Jie Xinhua Technology Co., Ltd.

JXHSV05P-06033-f

Nozzle thermistor SV05P

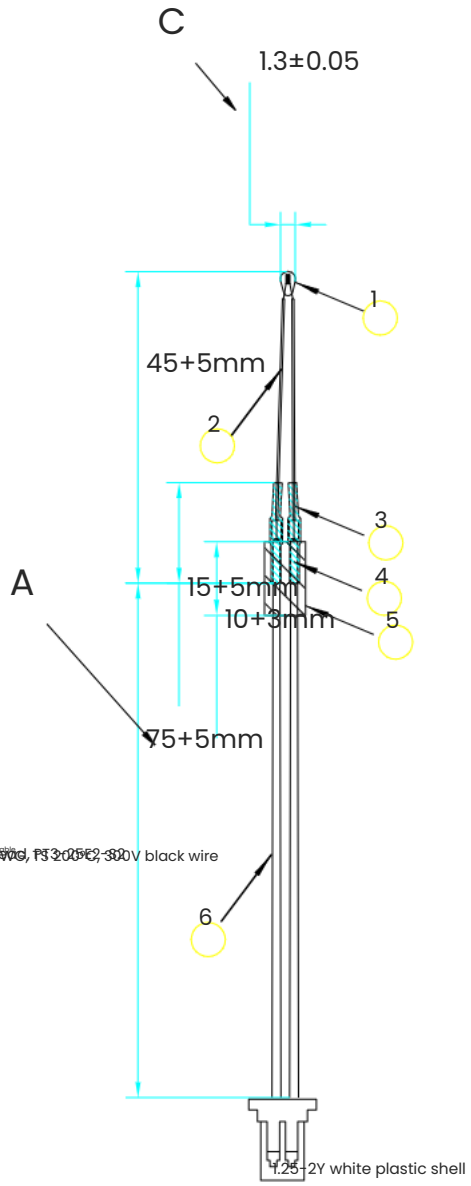
version A Tolerance changed to ±0.05 B A2

mark A1 Original size is 65mm, lengthened to 75mm
